ONS-2014-165

Subject: Duke Energy Carolinas, LLC  
Oconee Nuclear Station, Units 1, 2, and 3  
Docket Nos. 50-269, -270, and -287  
Emergency Plan Revision 2014-003

SUBJECT: Emergency Plan Revision 2014-003

## FIGURE H-2

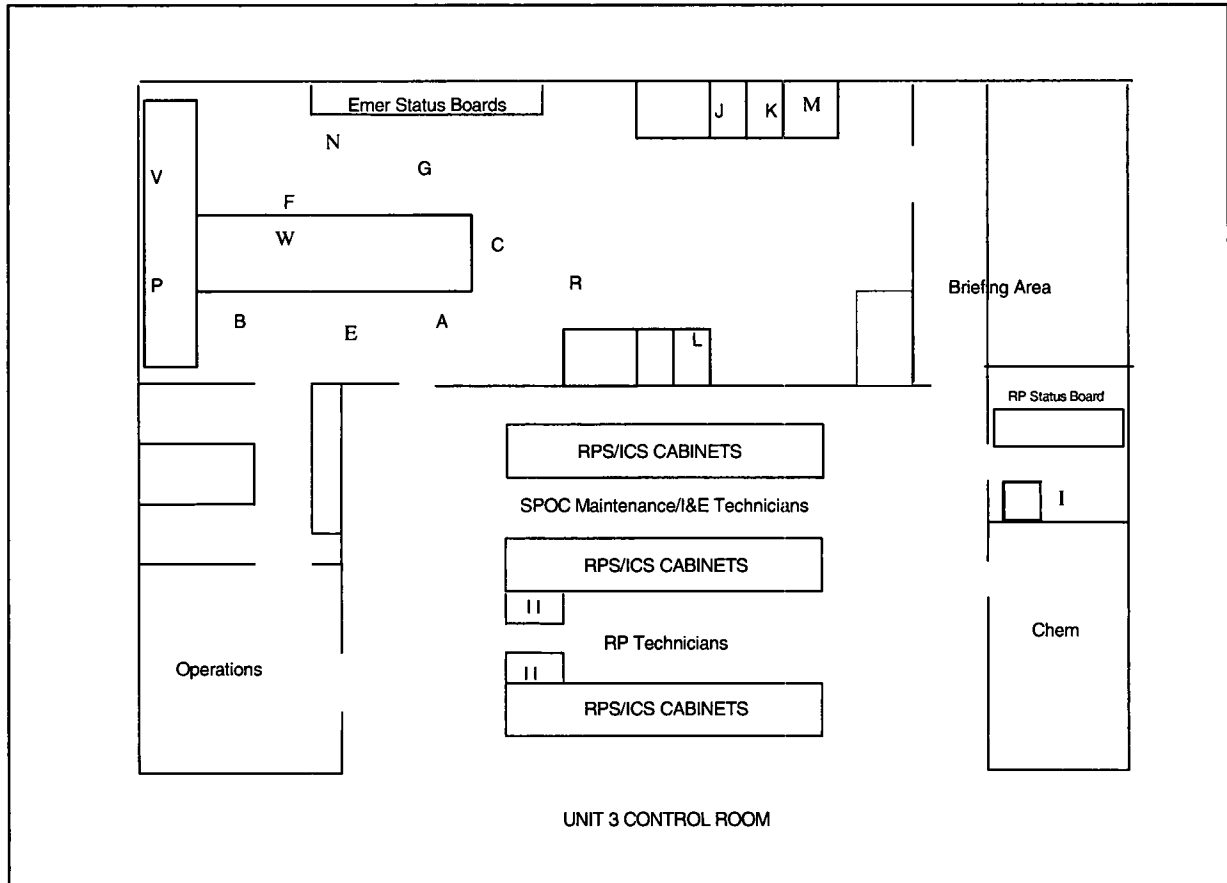
25	Section H Figure H-2 Page H-12	TYPICAL OPERATIONAL SUPPORT CENTER	TYPICAL OPERATIONAL SUPPORT CENTER (OSC)	Editorial - added acronym (OSC)
26	Section H Figure H-3C Page H-16	TYPICAL OCONEE JIC SET UP	TYPICAL OCONEE JIC SET UP <u>(ALTERNATE EMERGENCY RESPONSE FACILITY)</u>	added (Alternate Emergency Response Facility) to title consistent with NEI 13-01
